EPC STORMWATER REVIEW COMMENTS
IN ORANGE BOXES WITH BLACK TEXT

VOLLMER ROAD (BARBARICK) - INTERIM CONDITION

GRADING AND EROSION CONTROL PLANS

VOLLMER ROAD (BARBARICK)
 -INTERIM CONDITION
 INITIAL/INTERIM GESC

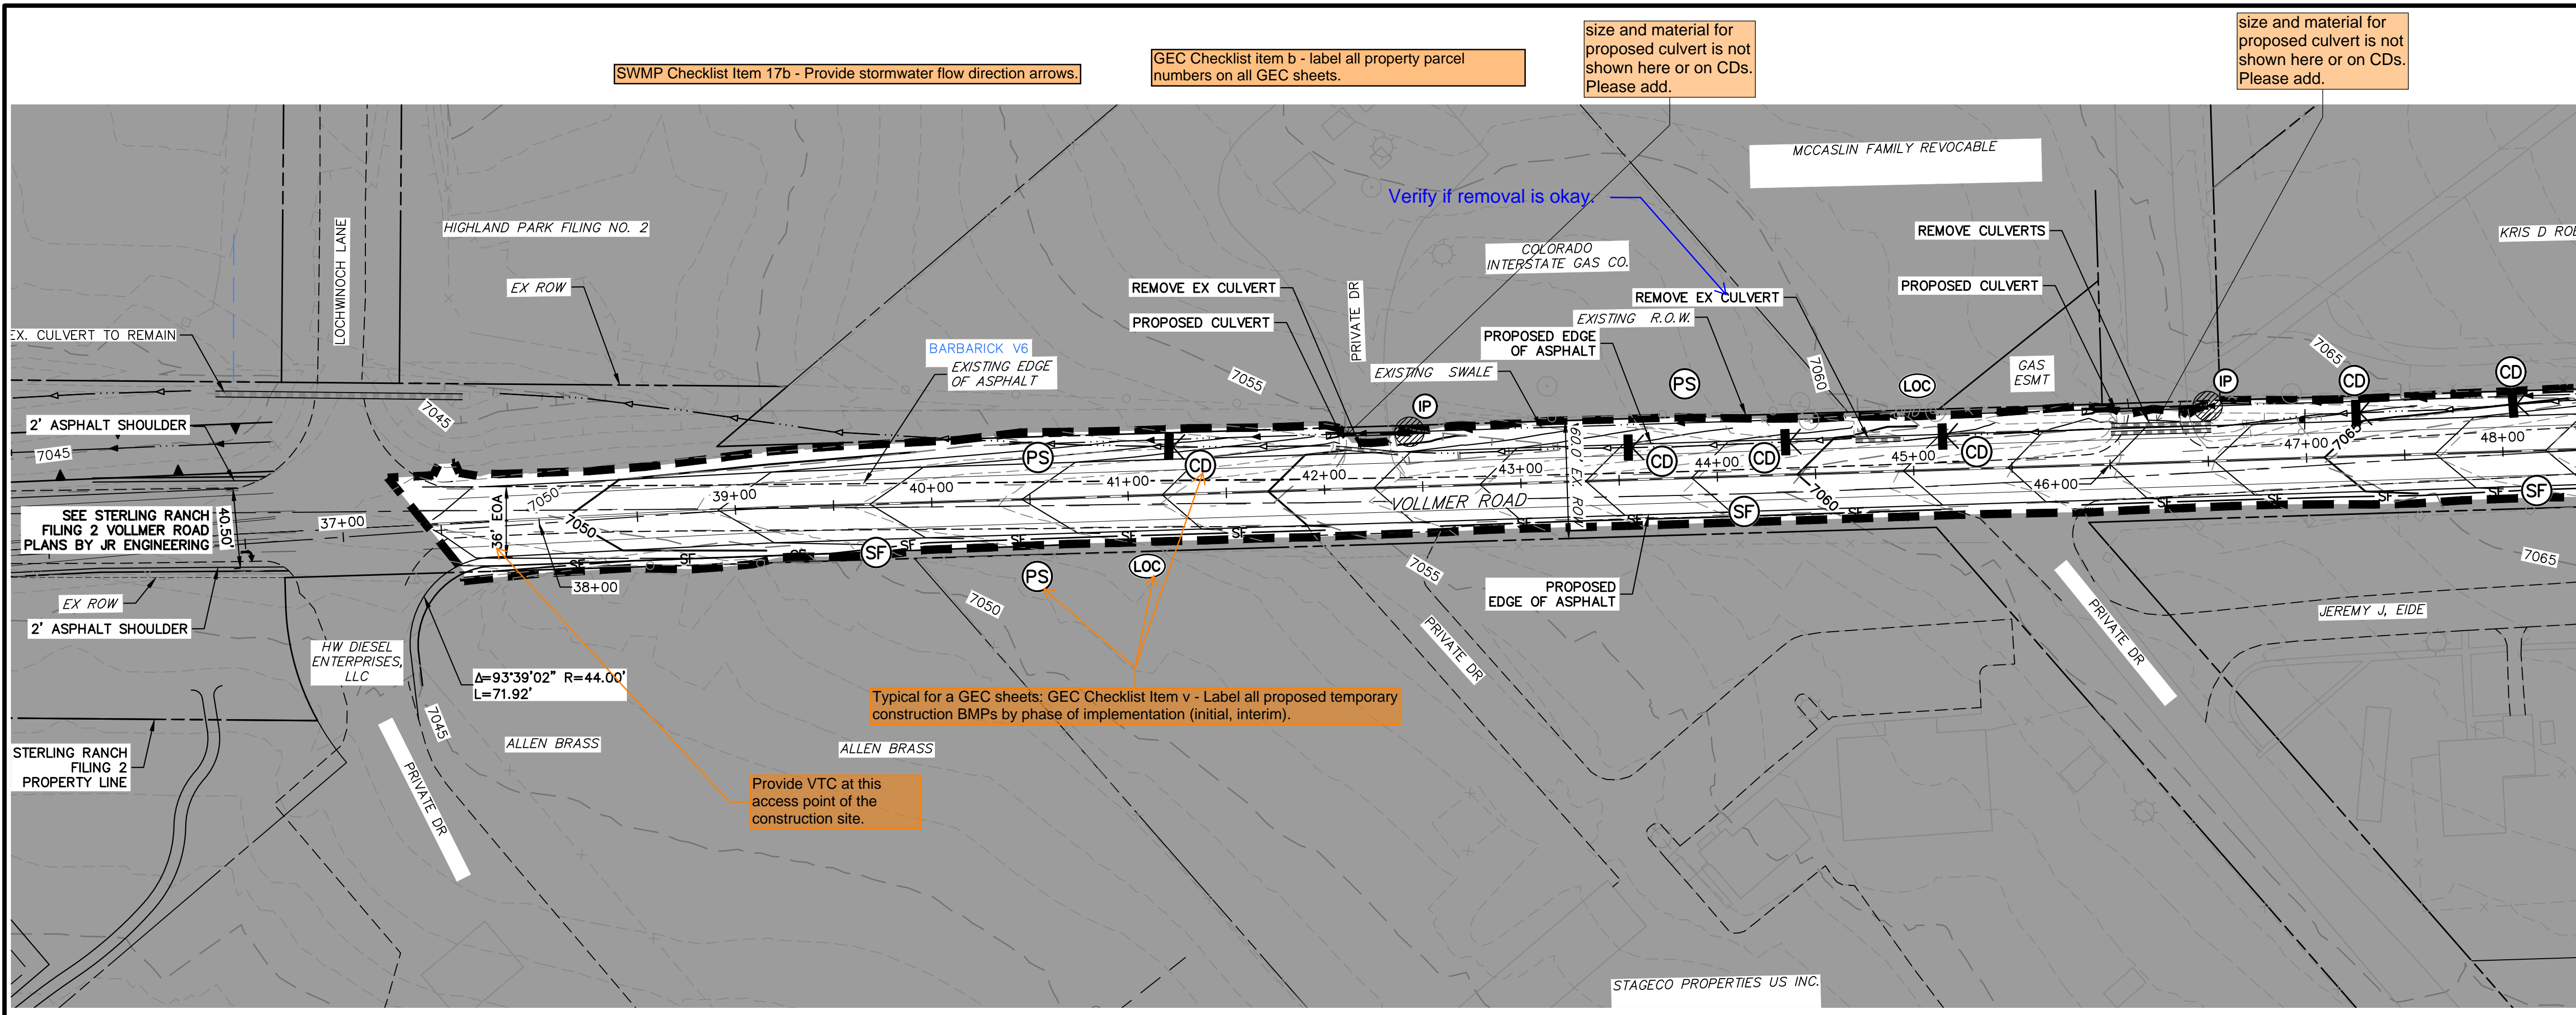
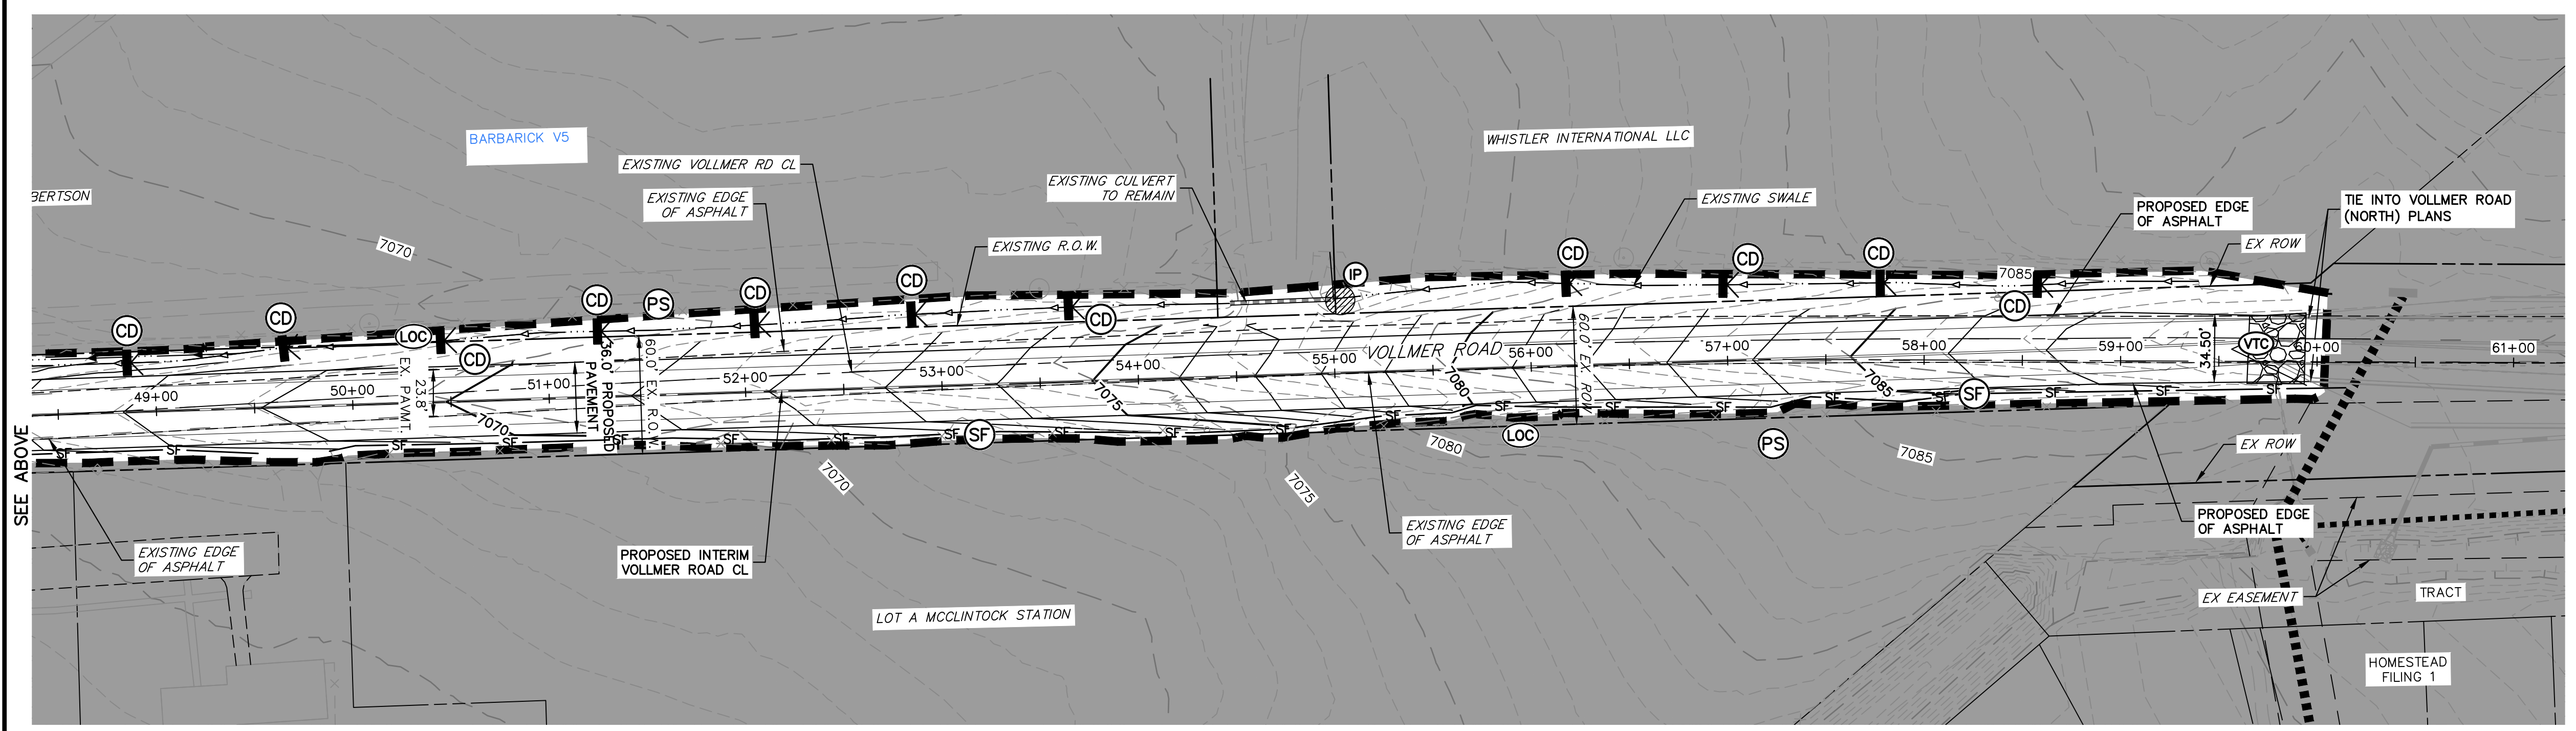
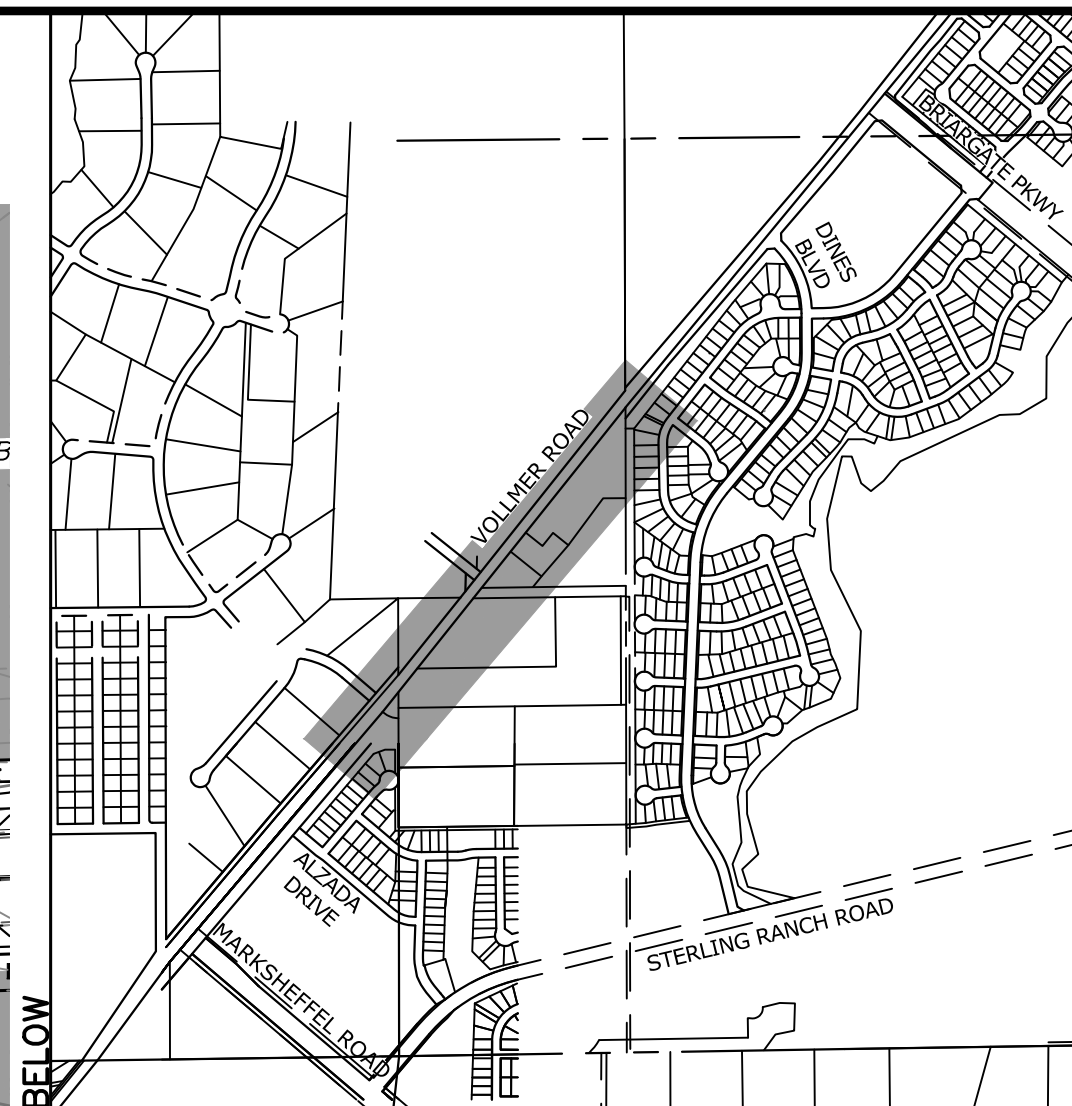
SWMP stated a different percent. Verify and update so both match.

GEC Checklist Item g: Show all existing utilities.

Add construction marker symbol and description to legend per the SWMP text.

show concrete washout
